RIDGWAY PLANNING COMMISSION

AGENDA

STAFF REPORT

Request: Replat
Legal: Blocks 2 and 8, River Park Ridgway Business Park Planned Unit Development, Filing 1
Address: TBD Cora Street
Parcel #: 430516223067 and 430516202006
Zone: Light Industrial 1 (LI-1)
Applicant: Ridgway Light Industrial
Owners: Ridgway Light Industrial, LLC (Block 8) and Chad Baillie (Block 2)
Initiated By: Shay Coburn, Town Planner and Jen Coates, Town Manager
Date: October 30, 2018

REPLAT OF BLOCKS 2 AND 8 OF THE RIVER PARK RIDGWAY BUSINESS PARK FILING 1
LOCATED IN THE NW 1/4 OF SECTION 18
TOWNSHIP 45 NORTH, RANGE 8 WEST, NEW MEXICO PRINCIPAL MERIDIAN
TOWN OF RIDGWAY, COUNTY OF OURAY, STATE OF COLORADO

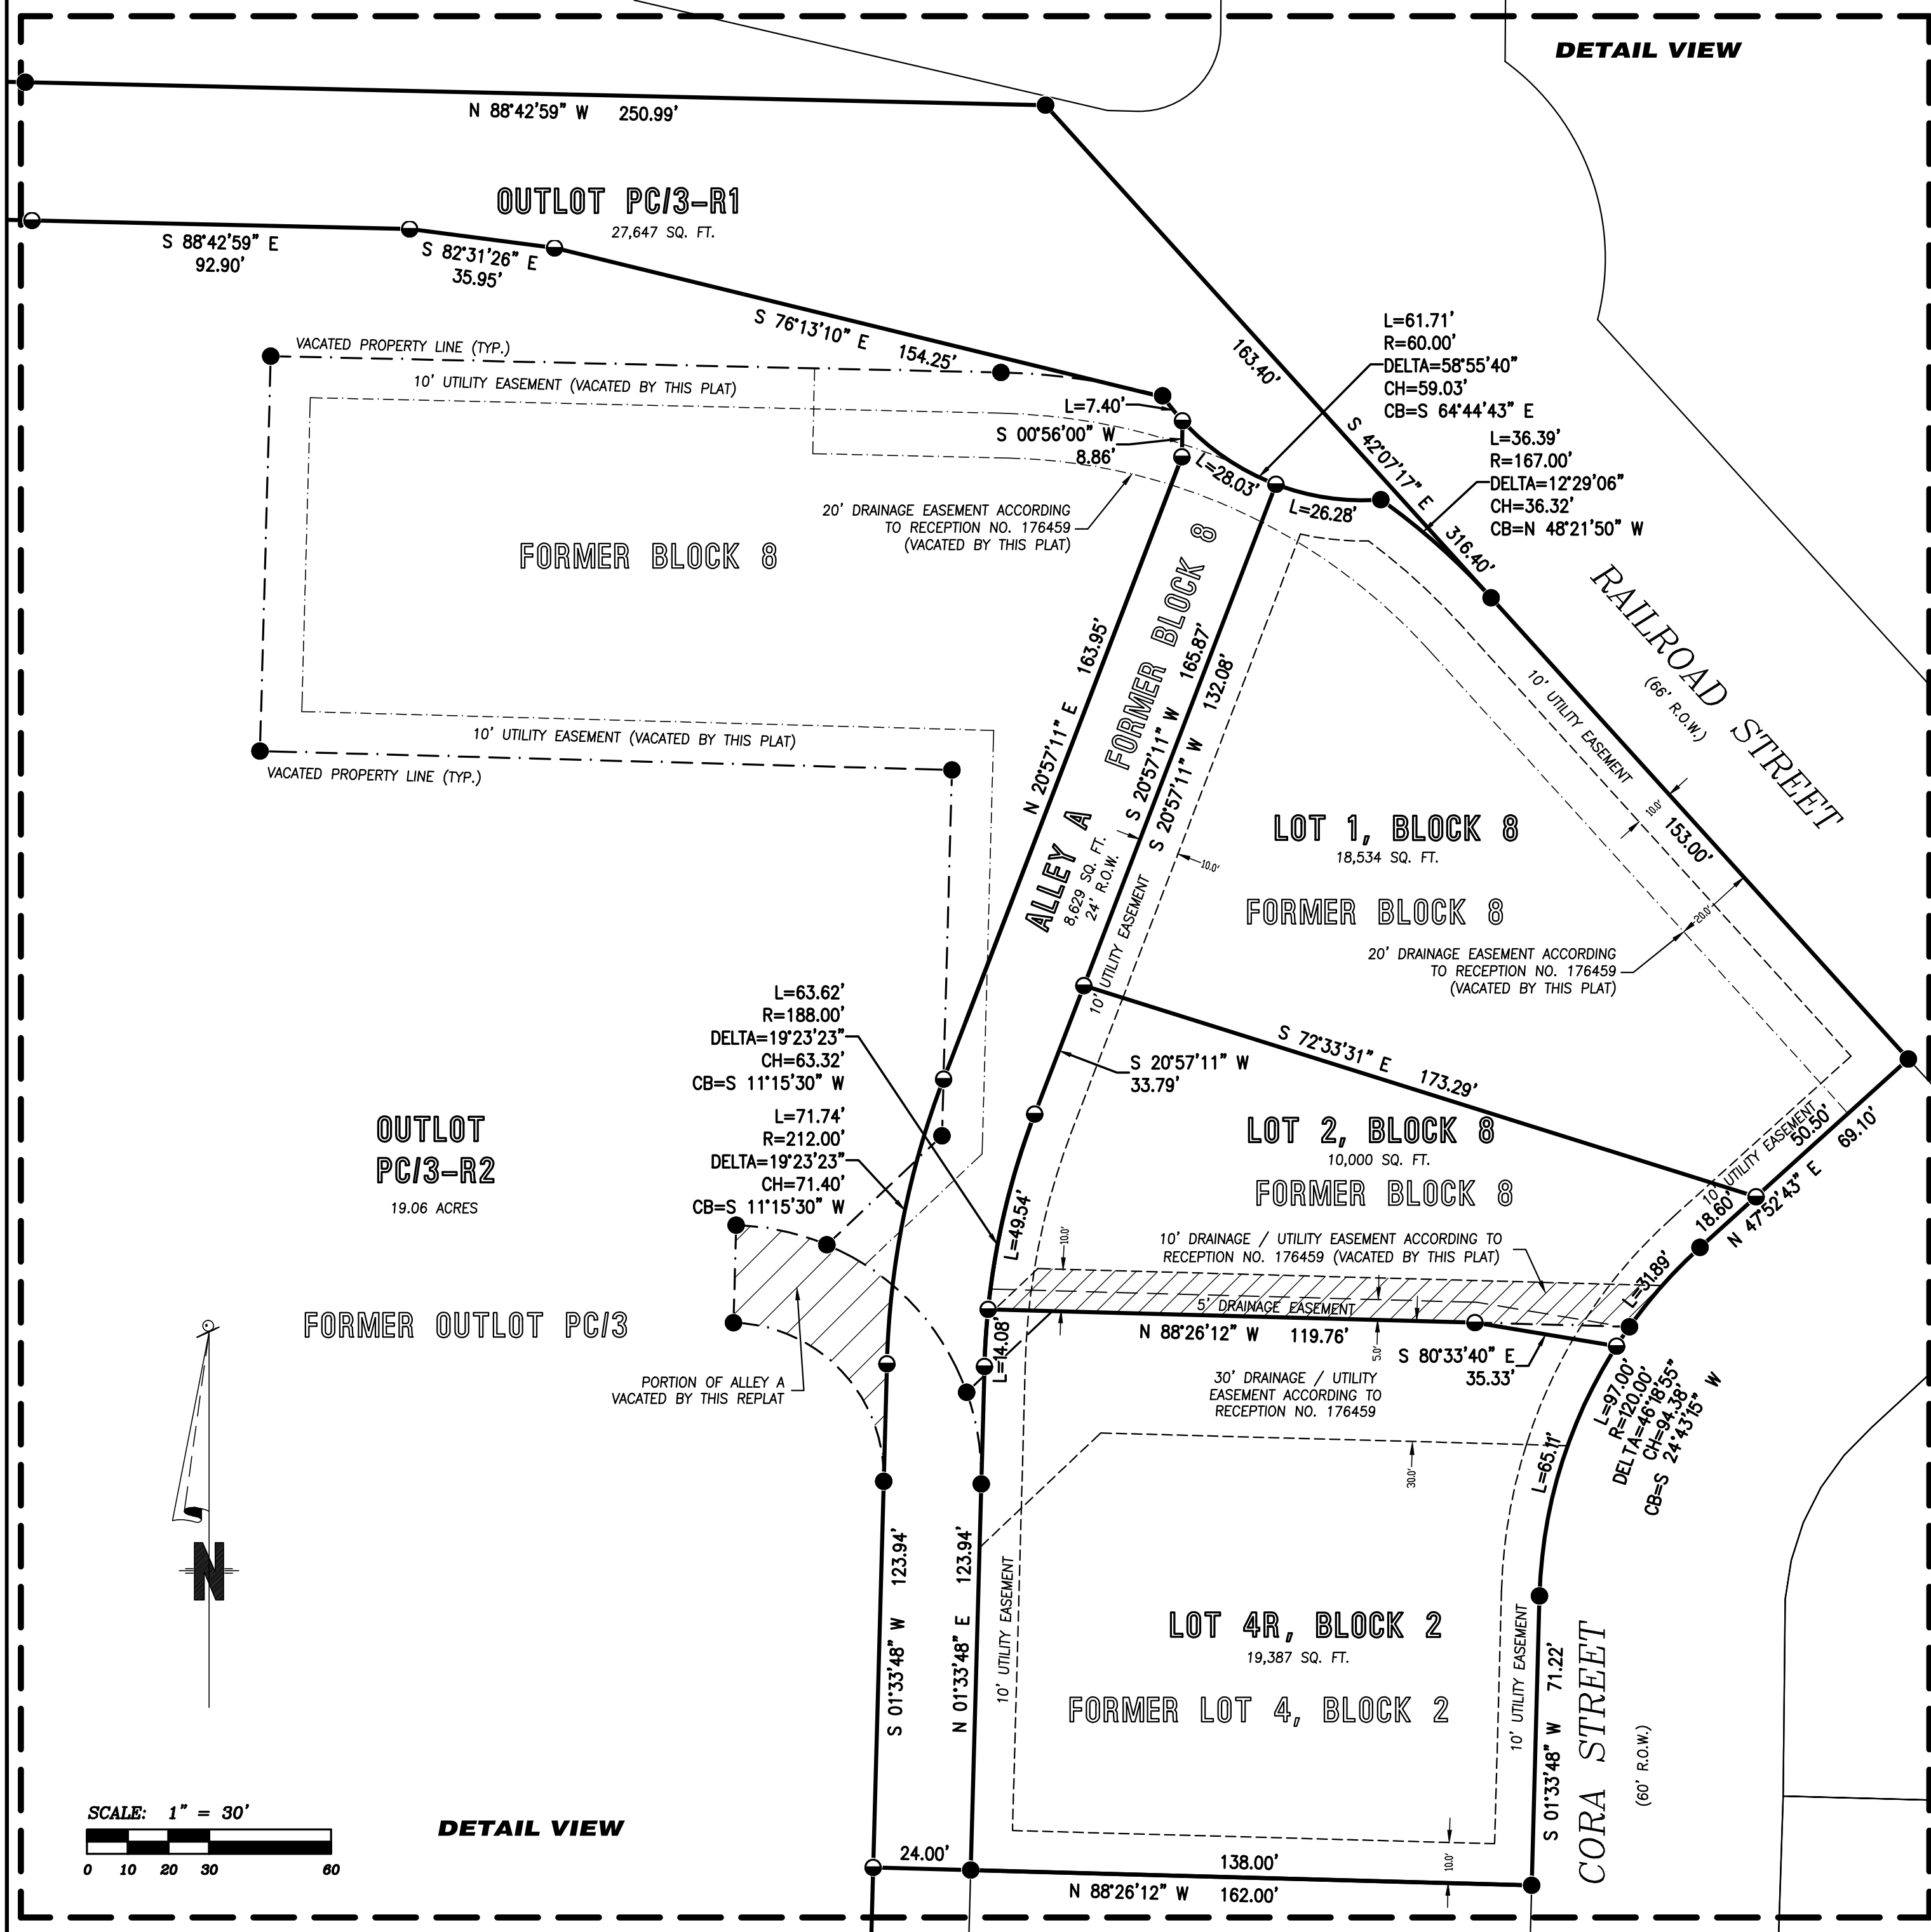
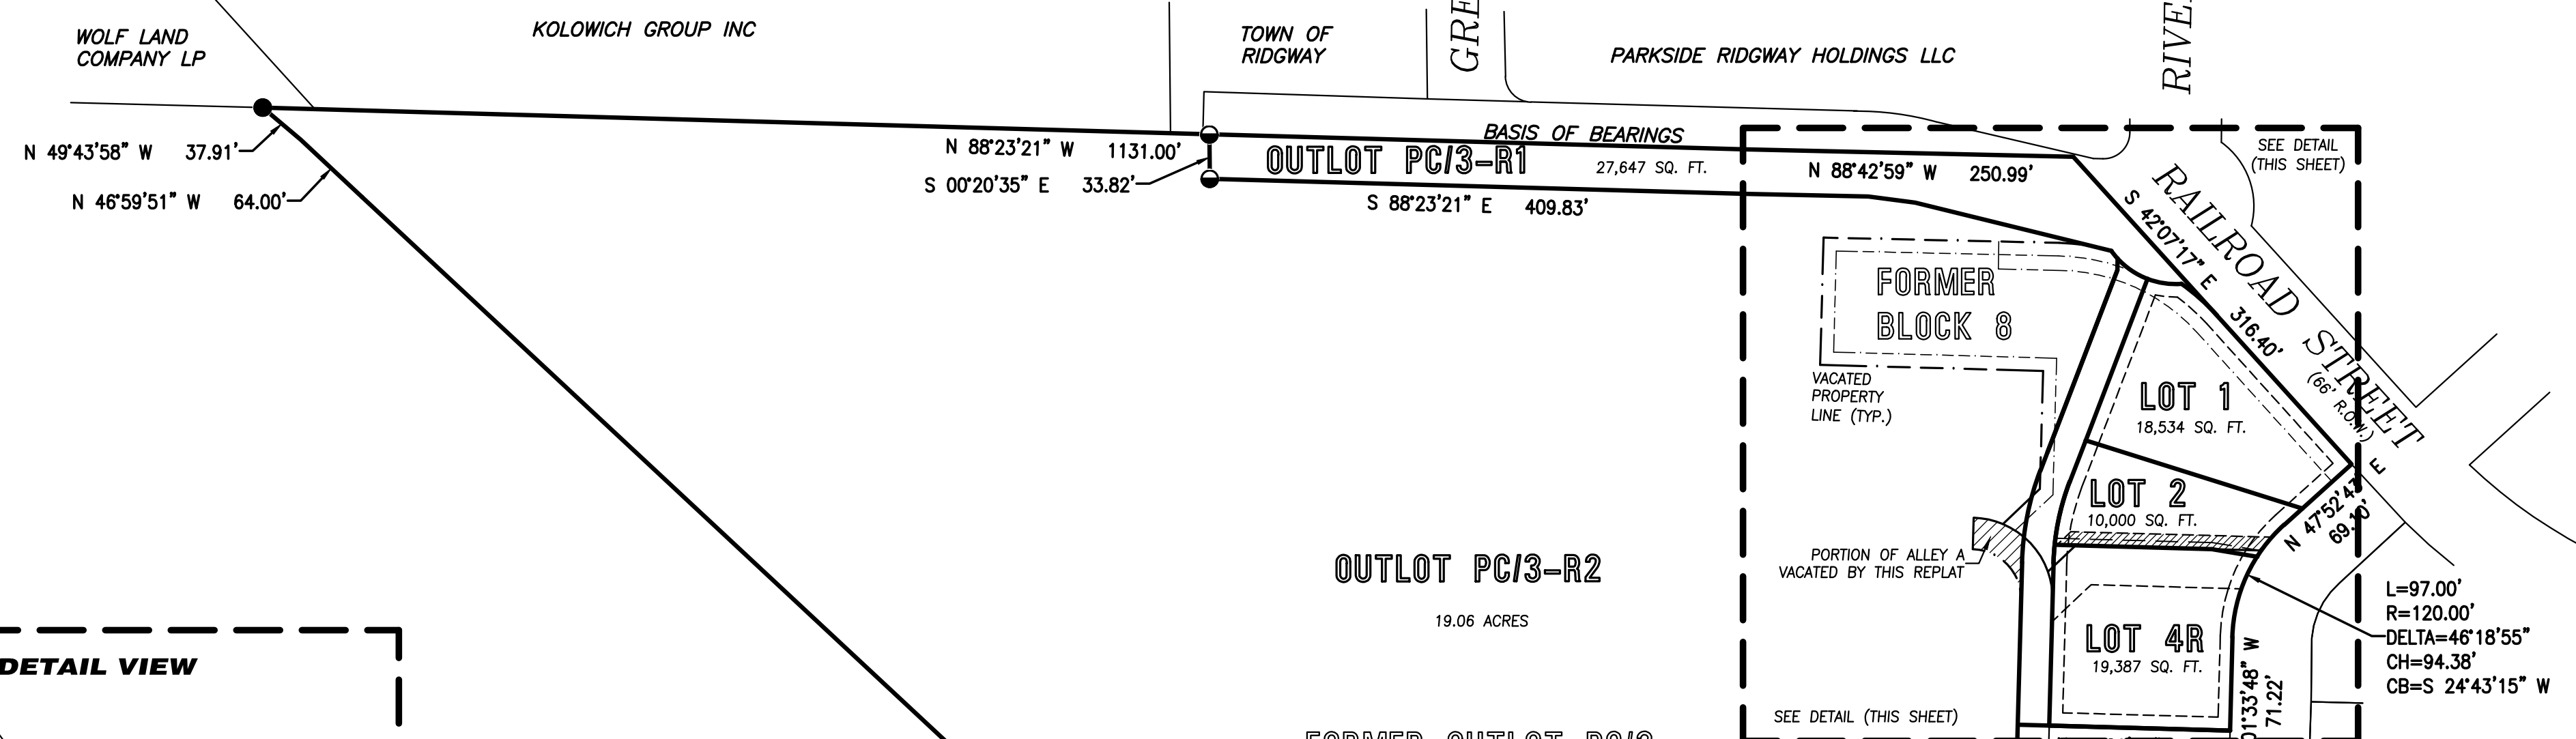
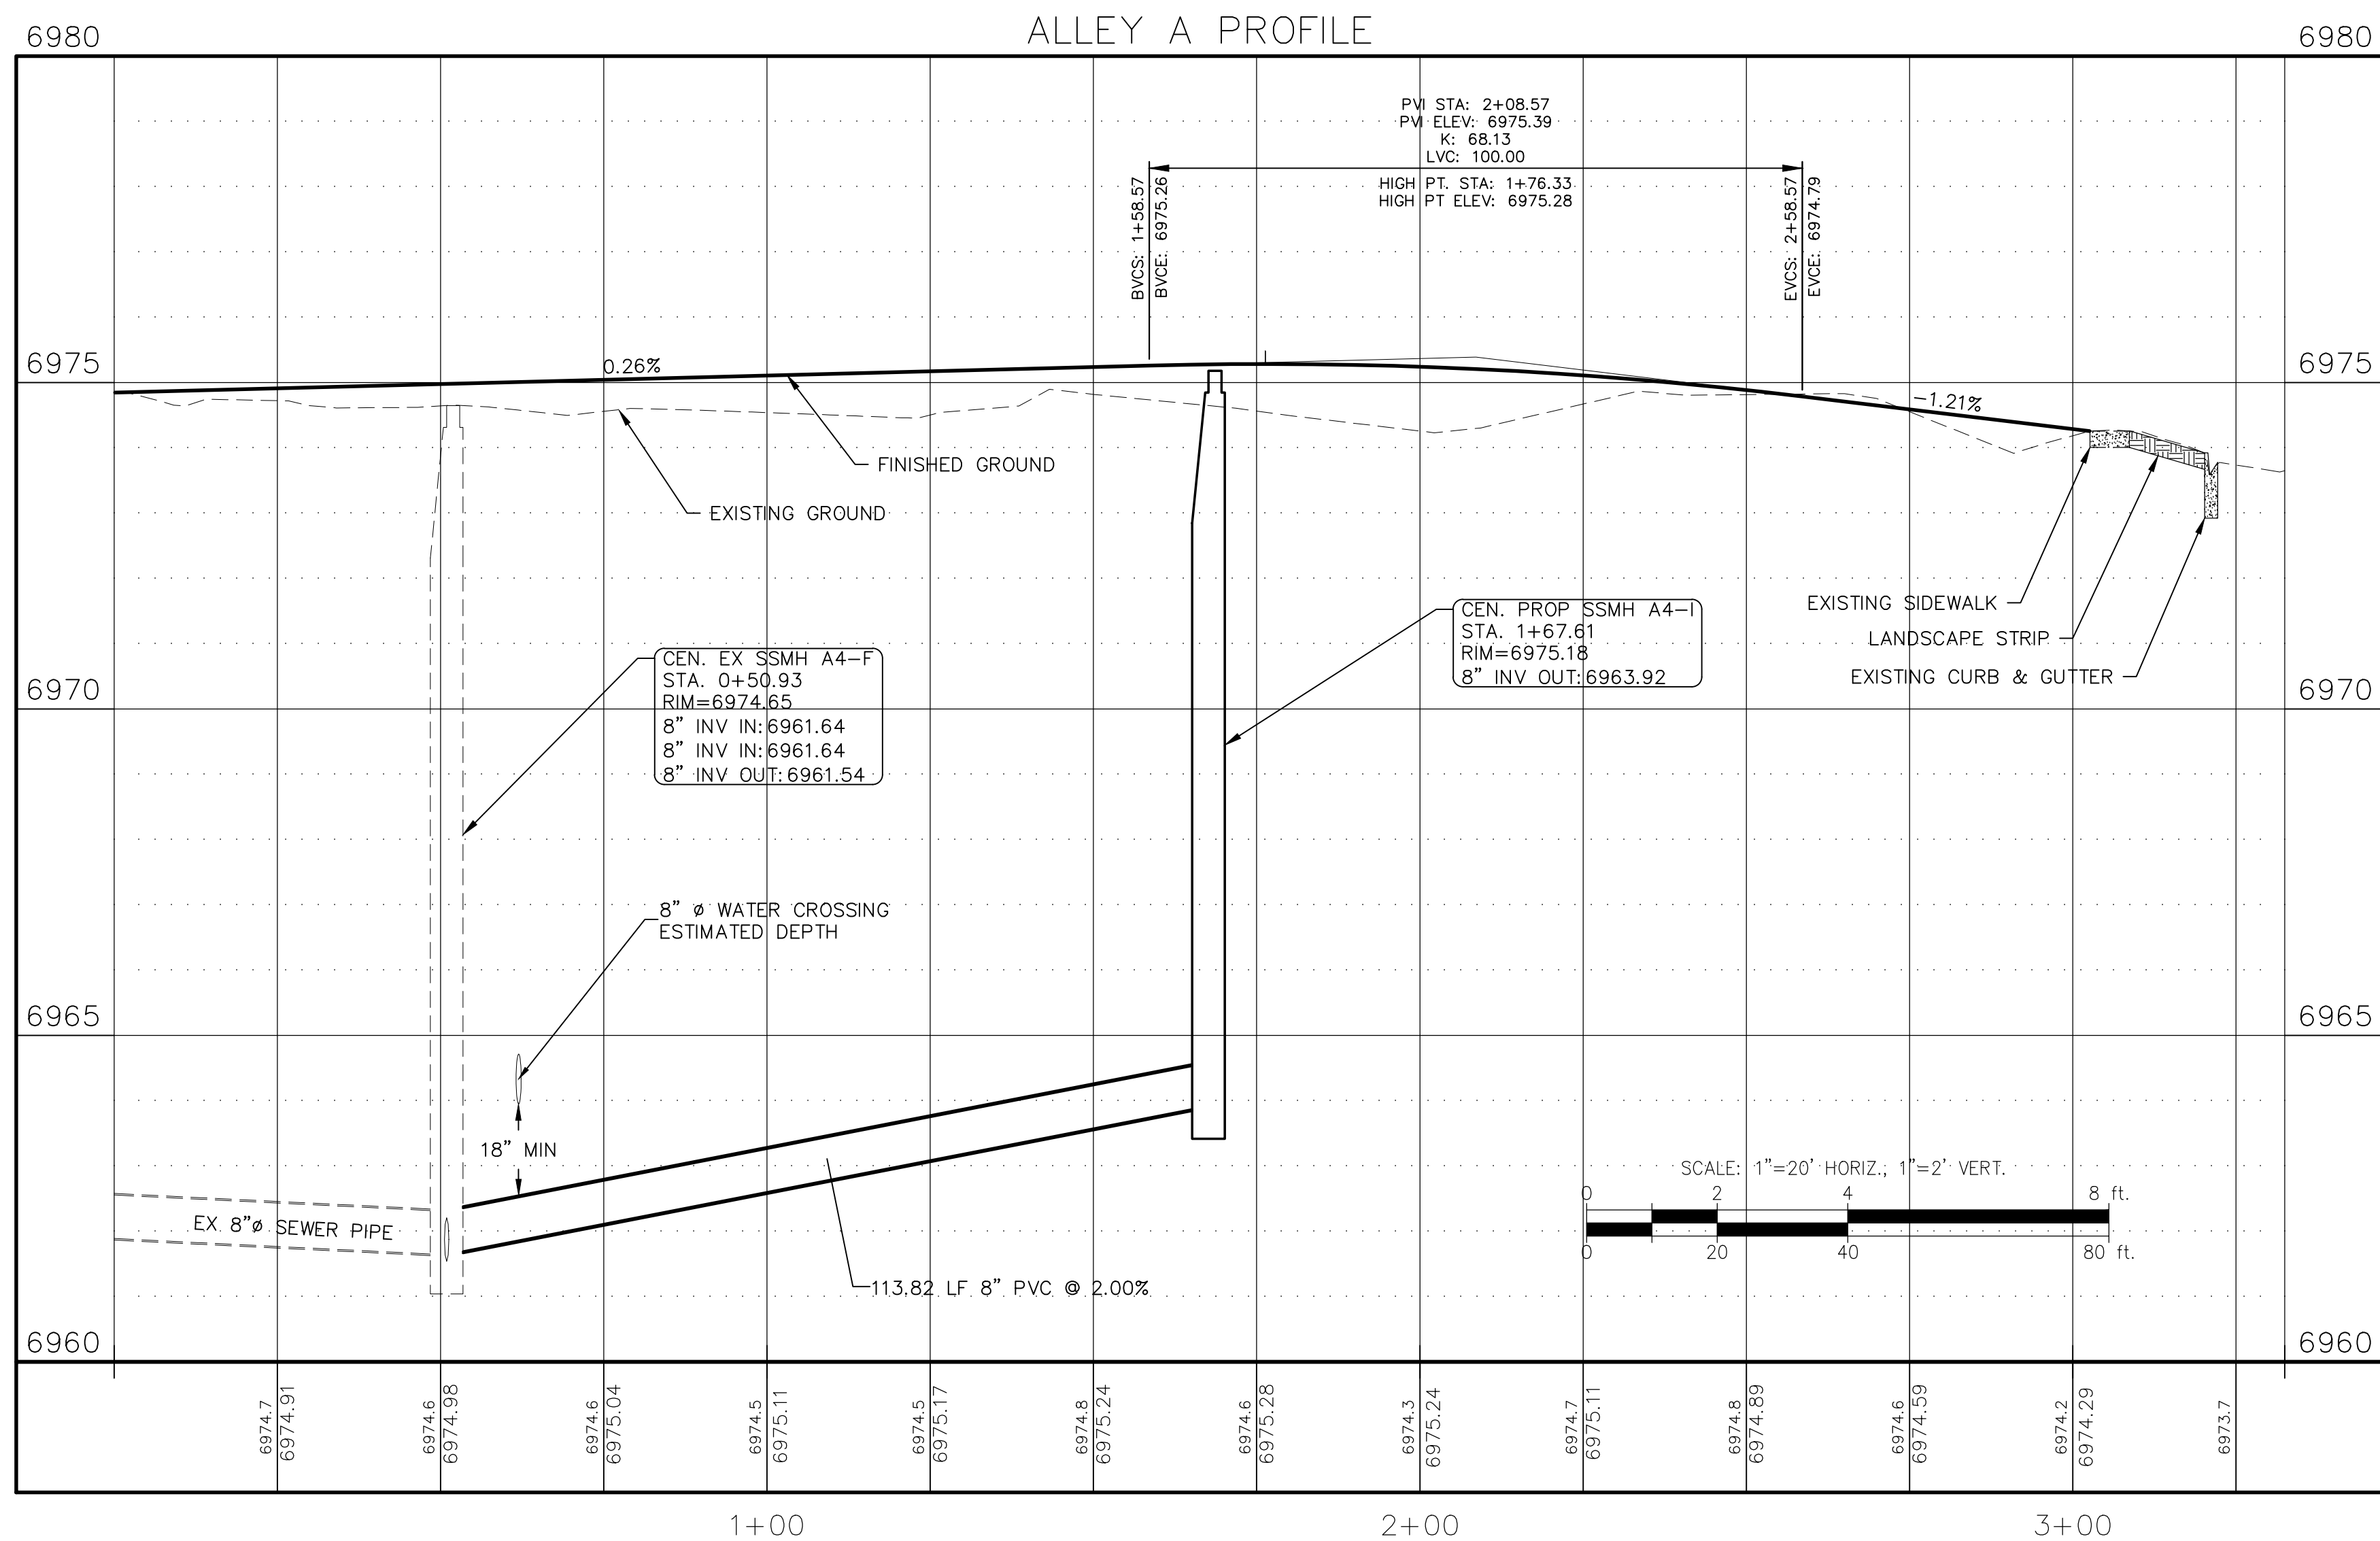
5. Fill in reception number under lienholder cert.
6. A plat note referencing River Park Ridgway Business Park Filing 1 (as shown on all prior replats for the Industrial Park) needs added to the map

7. Add Excise Tax note - Add "zero (0). No development excise tax has been paid." to the end of note 6.
8. Do the titles of Lot 4 and Outlot PC/3 need to change to Lot 4R on Block 2 and PC/3-R1 and R2? This seems confusing and that they should retain the same legal description with the proposed Outlot PC/3-R1 called out and dedicated as Railroad Street right of way.

9. The survey's notes are missing a lot of "fill in the blank" information.
10. Remove surrounding land owners from plat map.
11. Sheet 2 needs to say "Sheet 2 of 2"

12. The Town typically does not vacate easements without fully understanding the potential impacts. Here are a few questions about easement vacations:
 - a. Are there any utilities currently in the utility easements that are proposed to be vacated? This includes the area west of the alley and the south side of lot 2 block 8.

- b. What was the purpose of the drainage easement along Railroad Street when this area was originally developed? Will drainage function without this easement? How?

- c. There is a 10' utility easement on the south side of block 8 according to filing 1. It appears as if it is proposed to be vacated. Staff is unsure that there was ever a 10' drainage easement on this property so that may not need to be vacated. Is the proposal to add a 5' drainage easement here? The language on the plat needs to be cleaned up a bit for clarity. Maybe it should say "10' utility easement according to Reception no.

176459 (vacated by this plat)" as to not be confused with the 5' drainage easement that is being added.
